Concerned Citizens for Nuclear Safety
107 Cienega Street
Santa Fe, NM 87501
Phone: (505) 986-1973
Fax: (505) 986-0997

Embudo Valley Environmental
Monitoring Group
P.O. Box 291
Dixon, NM 87527
Phone: (505) 579-4076

Exhibits
In support of CCNS and EVEMG
comments regarding
the draft LANL SWEIS

Attachment 1: Figures for Exhibits 1-4

Figure F- 4 Plutonium-239 and Plutonium-240 Measured Mean Concentration Value in Groundwater [From Draft LANL SWEIS page F-4]

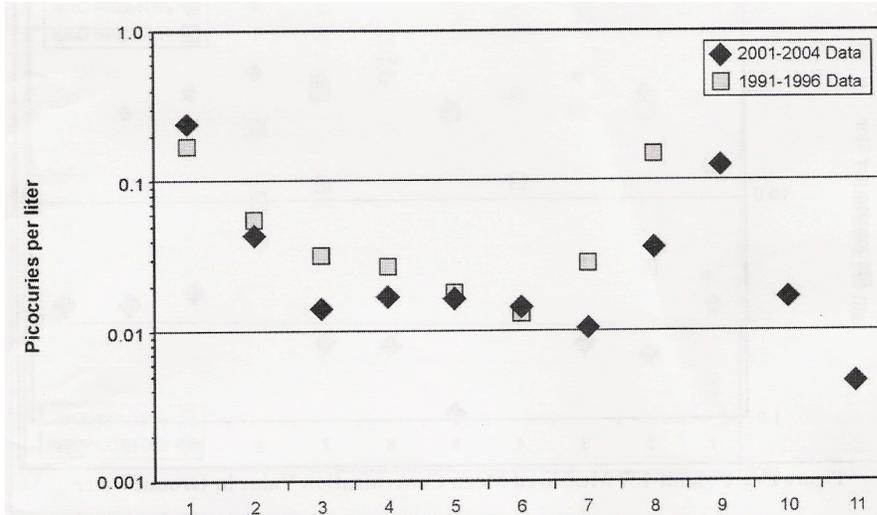
On Figure F- 4, the highest mean value for Pu-239 and Pu-240 are at location 1 and are in the groundwater samples from the monitoring wells installed in the alluvial sediments along the floors of the canyons that received plutonium laden waste waters from over 60 years of nuclear weapons research. The tables in Appendix F show that the maximum level of dissolved Pu-239 and Pu-240 in the shallow groundwater along the canyon bottoms is 1.78 pCi/L for a location in Mortandad Canyon. On Figure F-4 locations 9, 10, and 11 display the mean values for Pu-239 and Pu-240 in the groundwater samples from the LANL characterization wells installed in the regional aquifer, the Los Alamos County supply wells, and the City of Santa Fe wells in the Buckman well field as follows:

More alarming is the high level of Neptunium-237 in the drinking water produced from the supply wells for Los Alamos County and Santa Fe. Note that the maximum level measured in a Los Alamos County supply well exceeds the EPA MCL of 15 pCi/L and the recent research⁹ and action by the Colorado Water Commission¹⁰ establish the need for the New Mexico Environment Department to change the New Mexico Drinking Water Standard to 0.15 pCi/L. The mean value in the drinking water produced from the supply wells for Los Alamos County and for Santa Fe from the supply wells in the Buckman well field are above 10 pCi/L and far above the necessary drinking water standard of 0.15 pCi/L to protect public health.

Figure 1-2. Overall condition of screens for producing reliable and representative water-quality samples as of November 2005

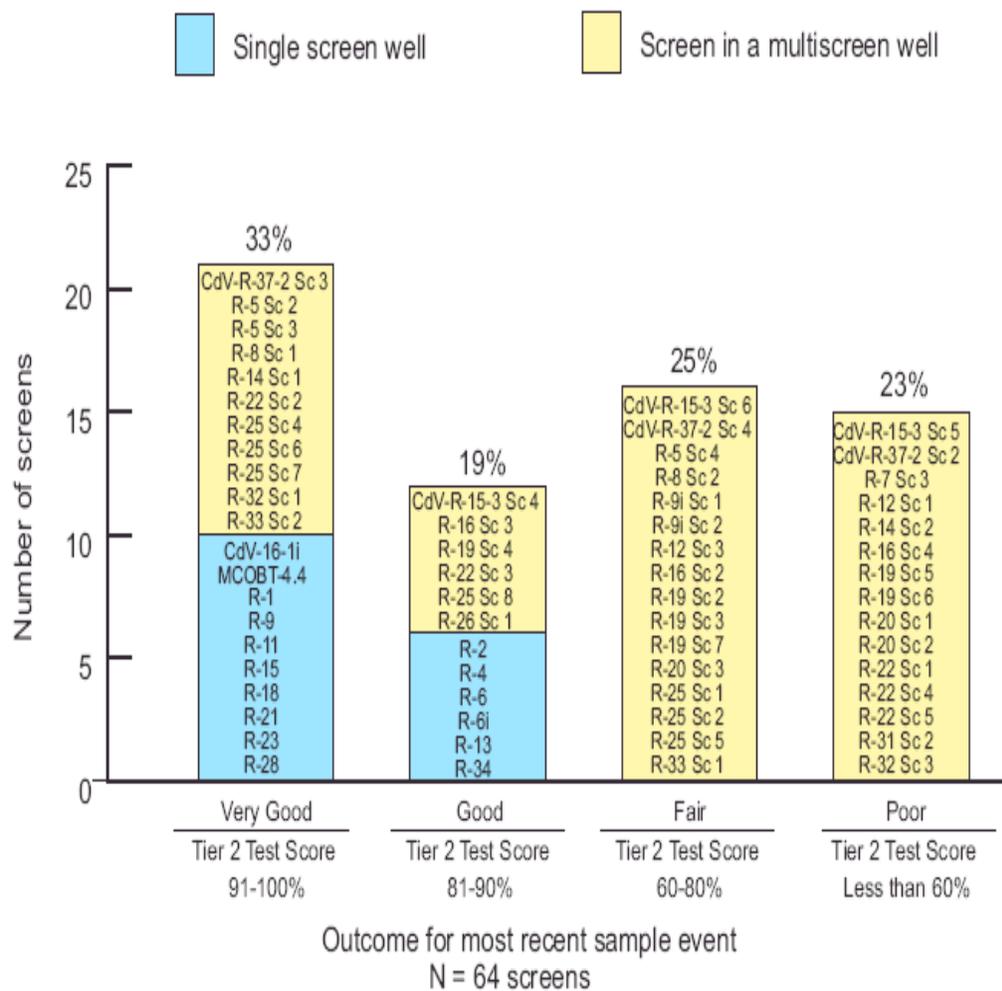
The findings in the LANL WSAR were from an automated statistical analysis of only the most recent water sample collected from each screened interval. Figure 1-2 (from the WSAR) presents the results of the statistical study of the water quality data for a single sampling event of 64 discrete screened intervals. Figure 1-2 presents grades for each discrete screen from Poor to Very Good. RCRA does not recognize the scheme used in the WSAR to assign grades to the water quality data. Furthermore, the WSAR made the arbitrary decision that screens with grades of Good and Very Good produced representative water samples and screens with grades of Fair and Poor did not. A LANL report⁶ summarizes the grading scheme in the WSAR as follows:

“The WSAR results indicated that for 64 screens analyzed, 16 of the wells had [31] screens that were in Fair or Poor condition and could not be relied upon to provide representative data or to detect contaminants in groundwater.”

materials. The bentonite clay have well known properties to mask the detection of contaminants in the water produced from the well. The borehole for the well was drilled with the mud-rotary drilling method that caused the screened intervals to be invaded with bentonite clay drilling mud and organic drilling additives. The LANL *Well Screen Analysis Report*⁹ identified that screen #2 and #4 in well R-16 do not produce reliable and representative groundwater samples (see Figure 1-2).

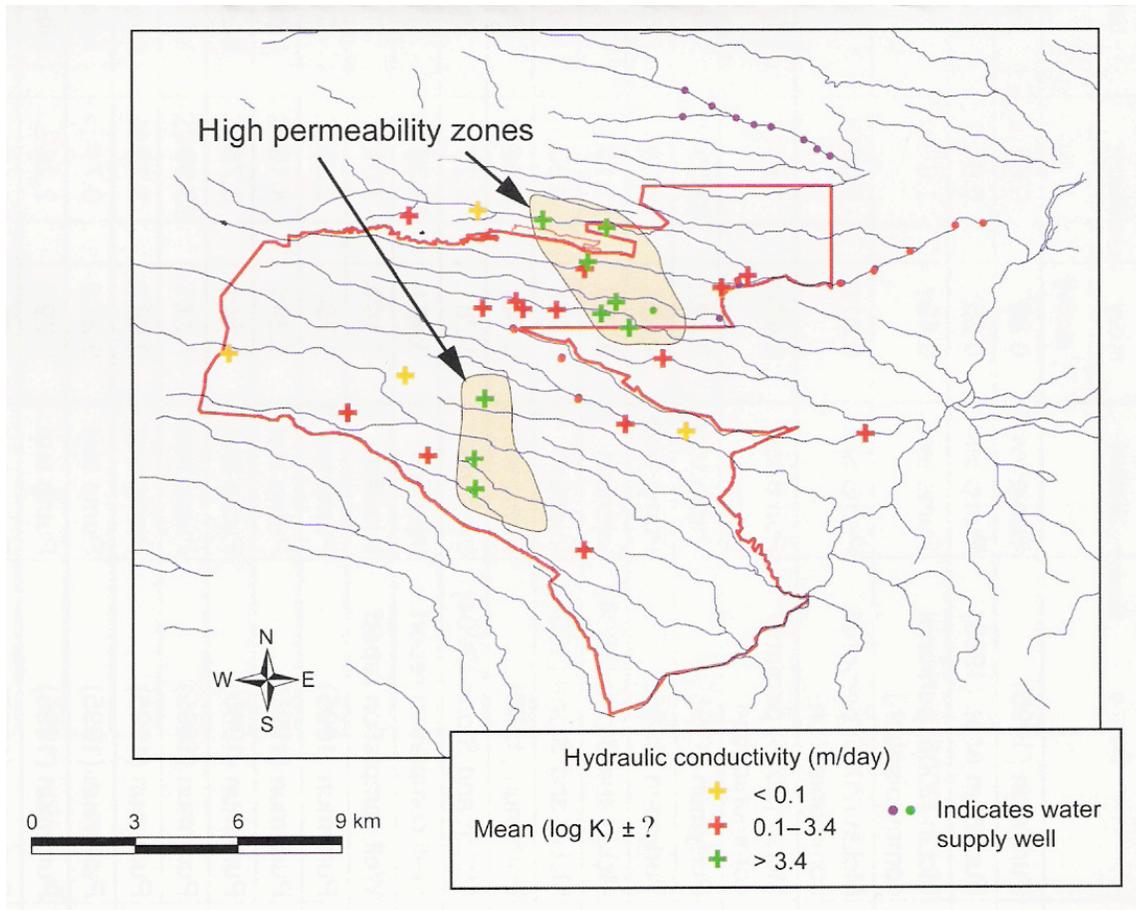
A serious mistake in the LANL *Synthesis Report*⁶ is the statement that "no high permeability zones occur east of well R-13". Well R-13 is located immediately north of the San Ildefonso Pueblo in Mortandad Canyon. Figure 1-5 is a map from the LANL *Synthesis Report* that portrays the regional aquifer to the west and south of well R-13 beneath the Pueblo property to have a permeability lower than 3.4 meters per day. Quite the opposite is true.

In fact, over a large part of the San Ildefonso Pueblo property, the regional aquifer has a permeability much greater than 3.4 meters per day. The available information from the LANL Hydrogeologic Workplan Project is that thick intervals of aquifer strata with a permeability greater than 20 meters per day occur over much and probably all of the Pueblo property to the west of the Rio Grande across the landscape to the south of well R-13. At the locations of wells R-34, R-22, and possibly well R-21, there are thick intervals of aquifer strata with a permeability greater than 40 meters per day. The LANL *Synthesis Report* is hiding the very large and very valuable groundwater resource on the San Ildefonso Pueblo.

3.1. The High Permeability of the Regional Aquifer at Well R-34. Figure 1-1 shows the location of characterization well R-34 in Cedro Canyon on the San Ildefonso Pueblo. The LANL *Synthesis Report* makes the mistake to describe the regional aquifer at well R-34 as having a low permeability of 1.07 meters per day. The spurious low permeability was measured by a pumping test that was affected by residual foam drilling fluids, and because of the mistakes that were made in the construction of the well. As described below, the available information show the regional aquifer at well R-34 to have a permeability greater than 40 meters per day.

- Because of mistakes, Well R-34 Pumping Test measured a SPURIOUS low permeability of 1.1 meters/day. The regional aquifer at well R-34 may have a permeability greater than 40 meters per day.

Figure 1-6. The LANL characterization wells R-16, R-20, R-21, R-22, R-23, and R-32 that surround the three RCRA regulated units MDA G (Area G), MDA L, and MDA H. None of the six wells meet the requirements of RCRA for monitoring groundwater contamination.

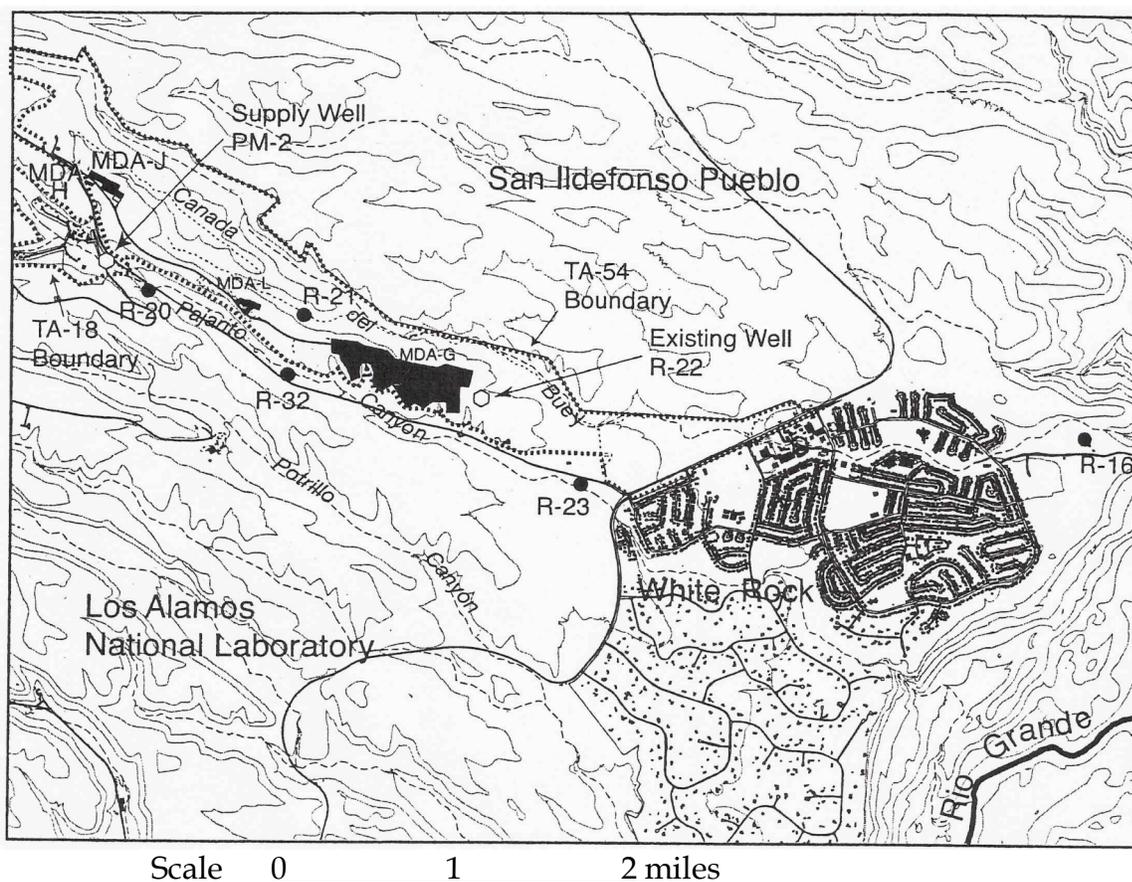
The six LANL characterization wells that are intended to meet the RCRA requirements for monitoring the three MDAs are the characterization wells R-16, R-20, R-21, R-22, R-23, and R-32. The six wells are displayed on Figure 1-6. None of the six wells meet the RCRA § 264 Subpart F requirements for monitoring the regulated units. Exhibit 1 describes the the properties of the drilling additives to mask the detection of LANL contaminants in the water samples produced from the 6 wells.

In addition, A fundamental deficiency is that RCRA 40 CFR § 264.95 requires for monitoring wells to be located at the immediate boundary of the regulated units to monitor the groundwater flowing from beneath the regulated units. Figure 1-6 shows that there are no monitoring wells located close to the downgradient boundaries of the three MDAs. The closest well to the downgradient boundary of a discrete regulated unit is well R-22 located approximately 500 feet east from the downgradient boundary of MDA G.

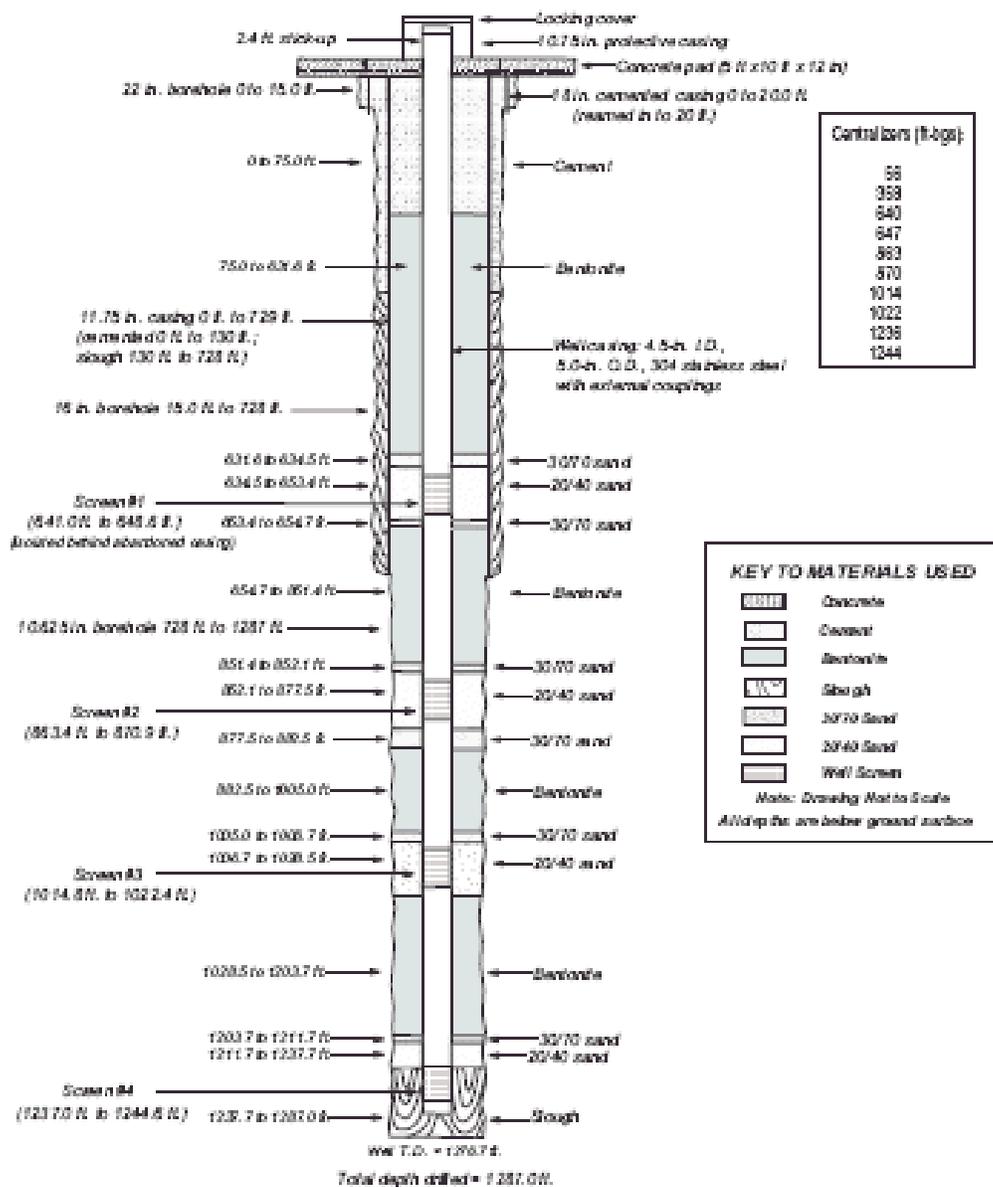
The danger of the hexavalent chromium plume to contaminate the groundwater at the Buckman well field is increased because of the mistakes that were made in the construction of well R-16, the LANL sentry well for LANL groundwater contamination traveling to the Buckman well field. Figure 1-7 displays the as-built construction of the multiple-screen well R-16. Screen #1 is blocked off by the retractable drill casing that was abandoned in the borehole. Screen #4 is surrounded by bentonite clay slough sediments⁸ that were not removed from the borehole before installing the backfill

Well R-16 Schlumberger Geophysics of Screen #4. Permeability increases

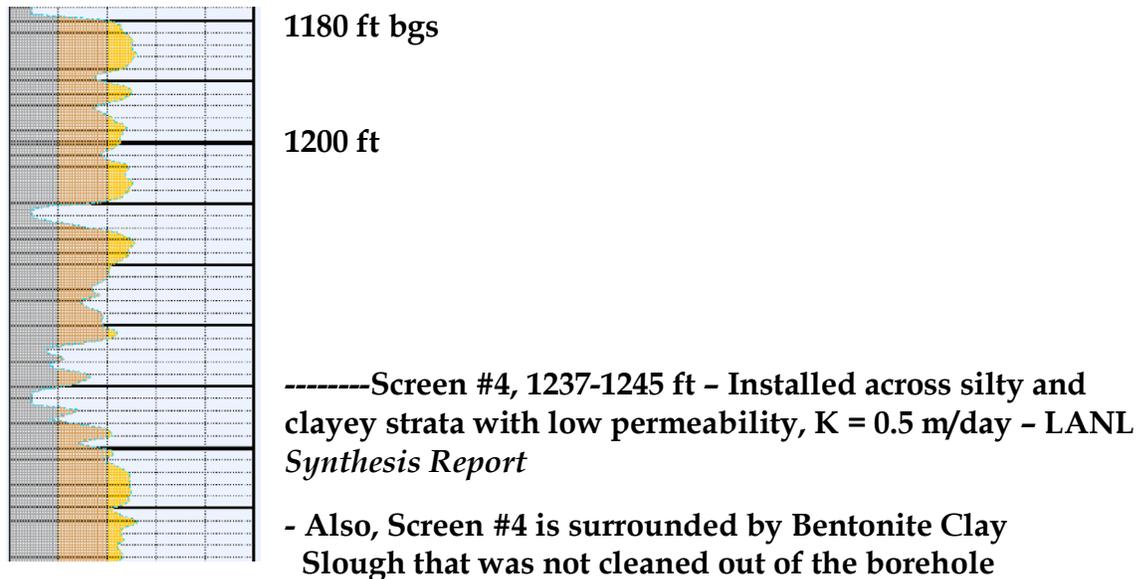
An additional mistake with the construction of well R-16 is that the Schlumberger borehole geophysics reveal that screen #4 was installed in a layer of strata with very low permeability and that layers of strata with markedly higher permeability are located above and below the strata that surround screen #4. The Schlumberger geophysics is displayed on Figure 1-8. Well R-16 is one of the monitoring wells for monitoring the release of contaminants from the RCRA regulated waste disposal sites at TA-54. The RCRA regulations require installation of well screens in the strata with highest permeability and the collection of representative groundwater samples. Well R-16 is not in compliance with RCRA 40 CFR §§ 264.90-100 (referred to as RCRA §264 Subpart F).

Strata with markedly higher permeability are at a depth of 1180 to 1188 feet and at a depth of 1252 to 1262 feet below ground surface (bgs).

- Well R-16 was drilled with the Conventional Mud Rotary Method.
- All of the screened intervals are invaded with large quantities of Bentonite Clay Drilling Mud and Organic Additives. None of the Screened Intervals in LANL Well R-16 meet the requirements of RCRA Subpart F.
